HUNTER POWER PROJECT HAZOP REPORT

| Document Information | | | | | |

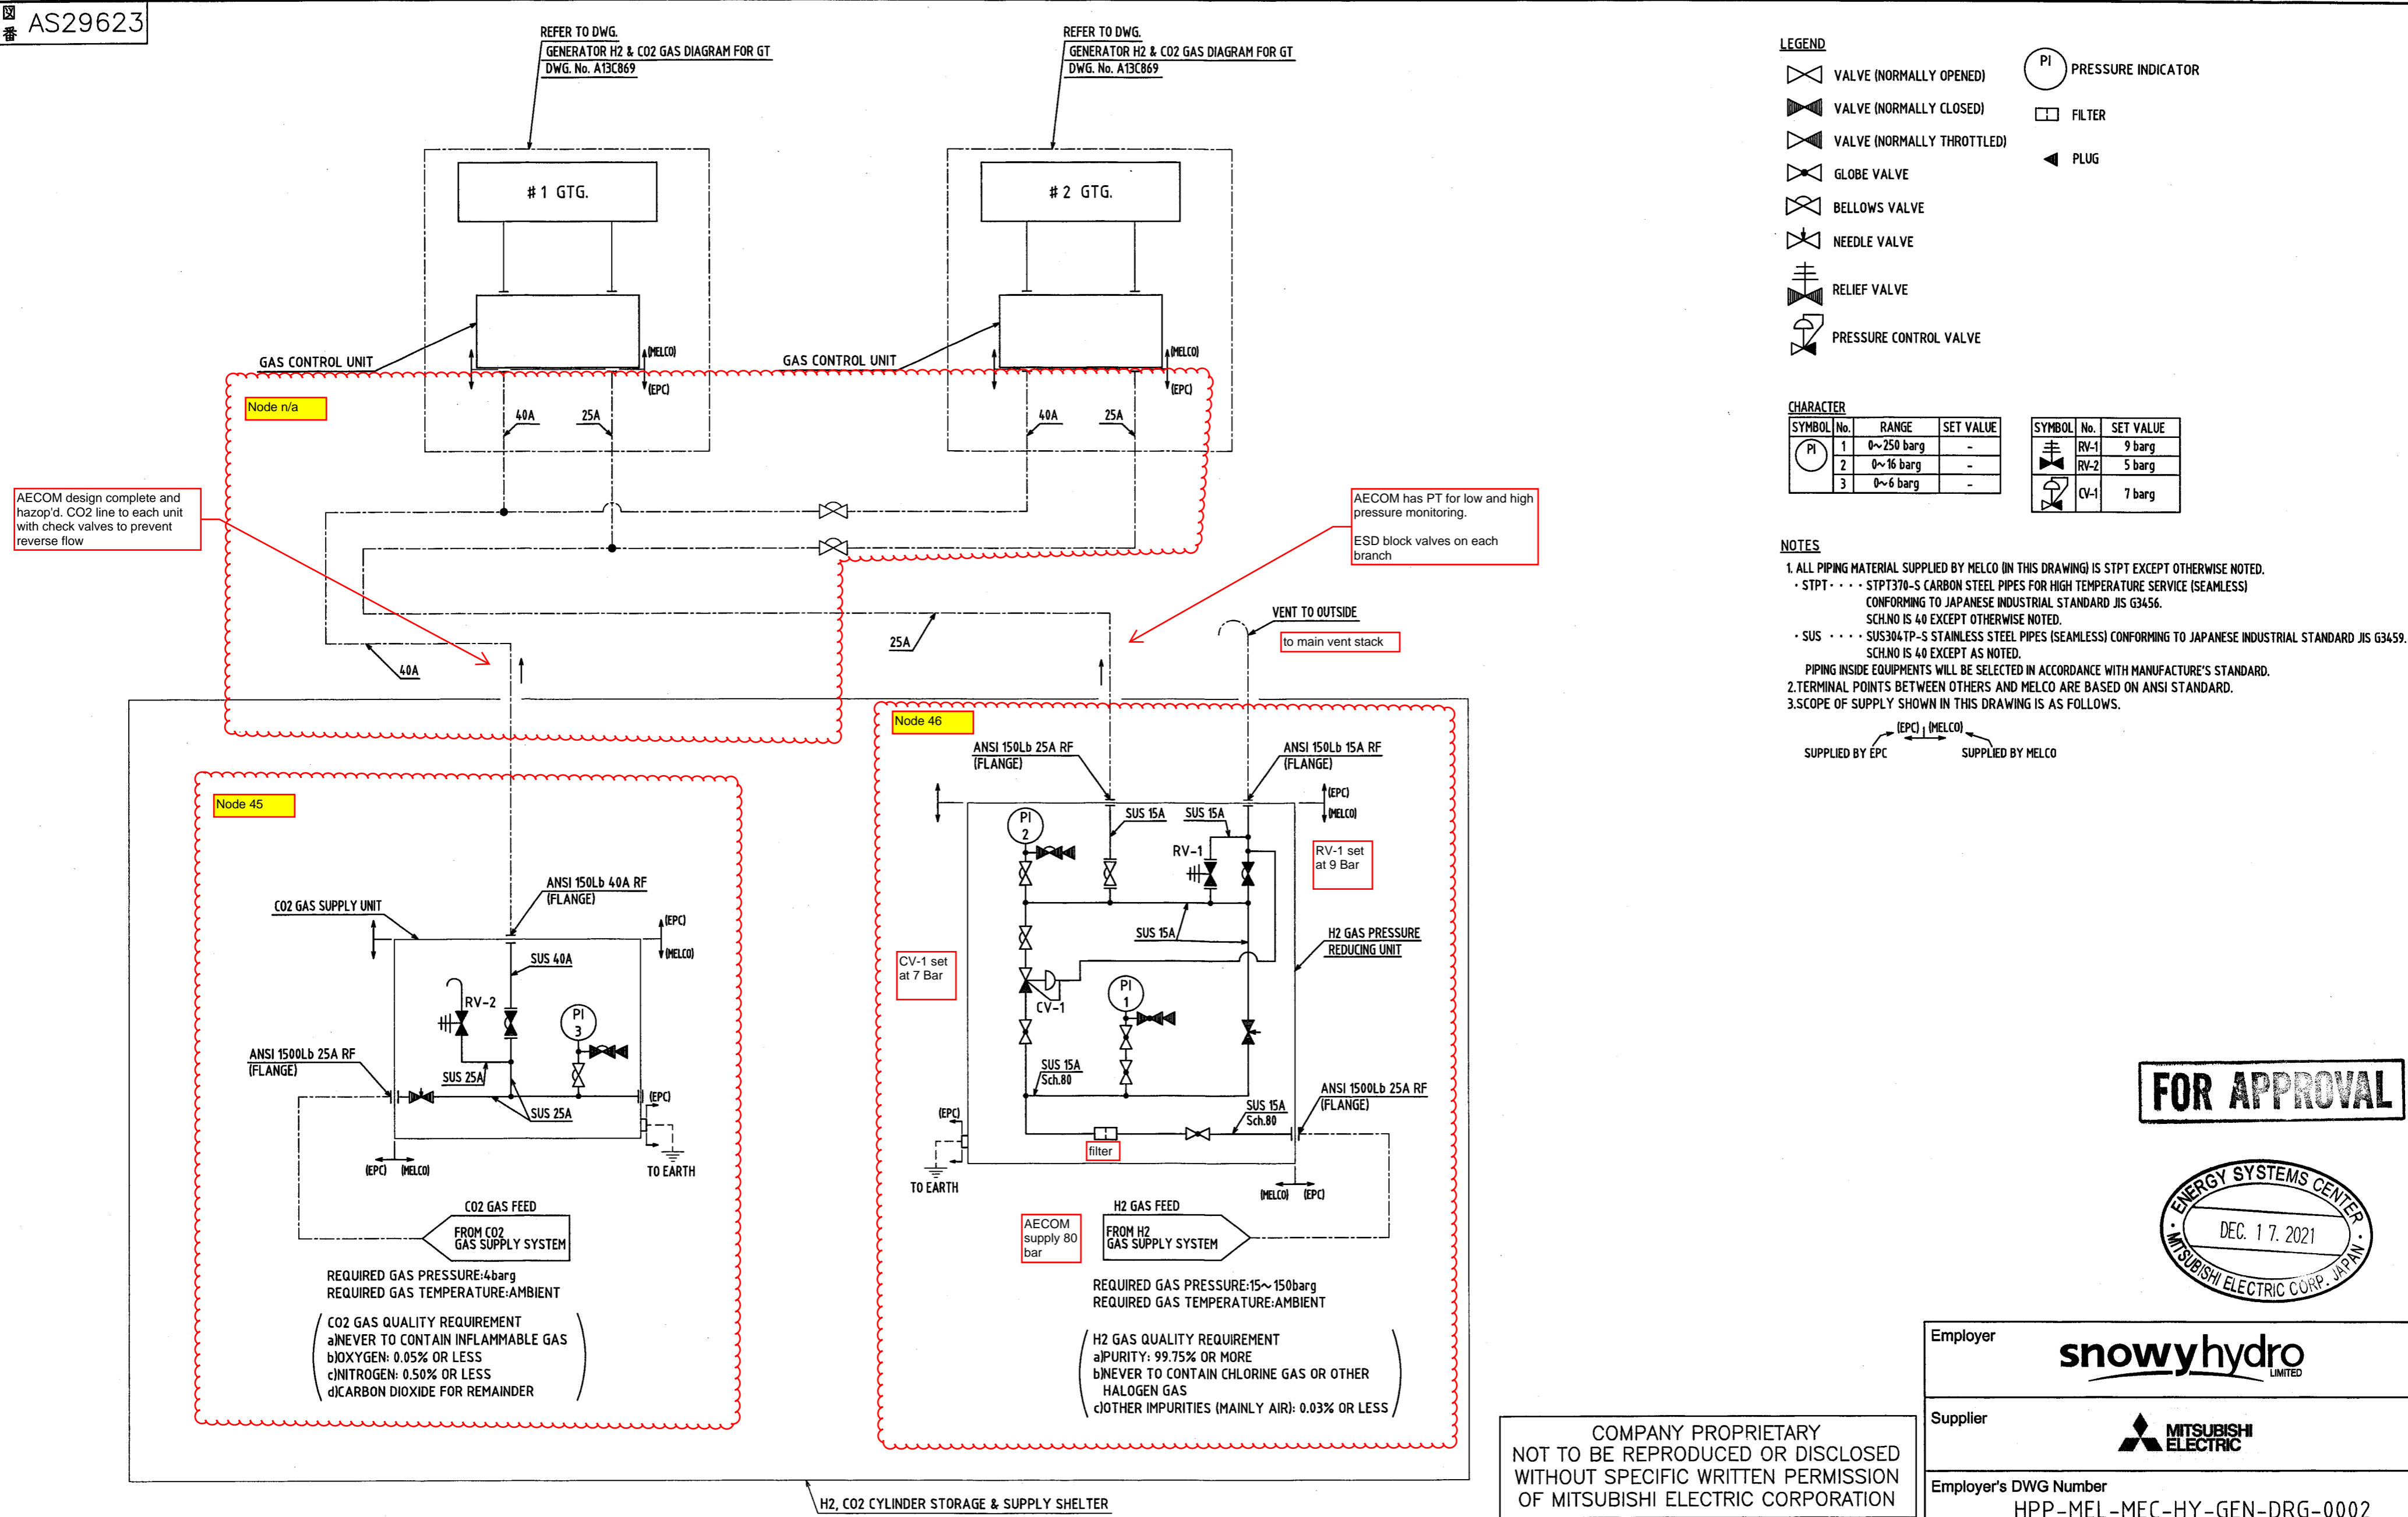
変更 CHANGE
 CAY6-03
